Re: Union Pacific Comments Regarding the Advanced Locomotive Emissions Control System (ALECS) Final Report

TIAX LLC ("TIAX") would like to respond to Union Pacific Railroad's (UPRR) comments to you (UPRR letter dated May 29, 2007 from Lanny Schmid, Director of Environmental Field Operations), concerning TIAX's final report "Evaluation of the Advanced Locomotive Emissions Control System (ALECS): ALECS Proof-of-Concept Testing at the Union Pacific J. R. Davis Rail Yard in Roseville, California" (Report).

Figure 1. ALECS Cost Effectiveness

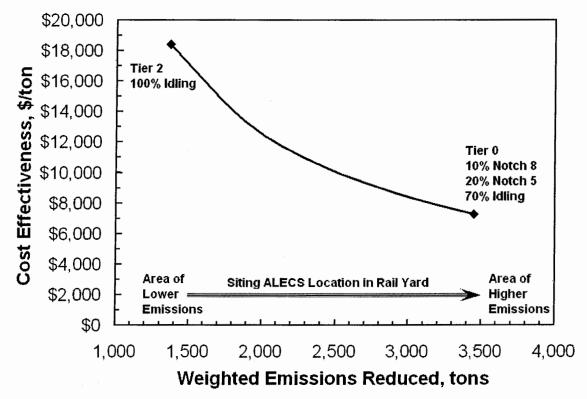
Table 1 shows a comparison of the above methodologies. The lowest cost effectiveness is obtained by performing a NPV or DCF analyses. The approach used by TIAX increases the costs and therefore increases the cost effectiveness. UPRR's approach, which is not recommended for trying to capture non-uniform annual costs, provides the highest costs and cost effectiveness. Interestingly, regardless of the financial method used the cost effectiveness estimates do not vary all that much from \$6,100 to \$7,300 to \$9,000. Far more important, as discussed above, is how often ALECS is used and how much emissions are reduced. This is the reason we developed Figure 1 (which is from our final

report's executive summary) which shows the sensitivity of costs and emission reductions to the ALECS cost effectiveness.
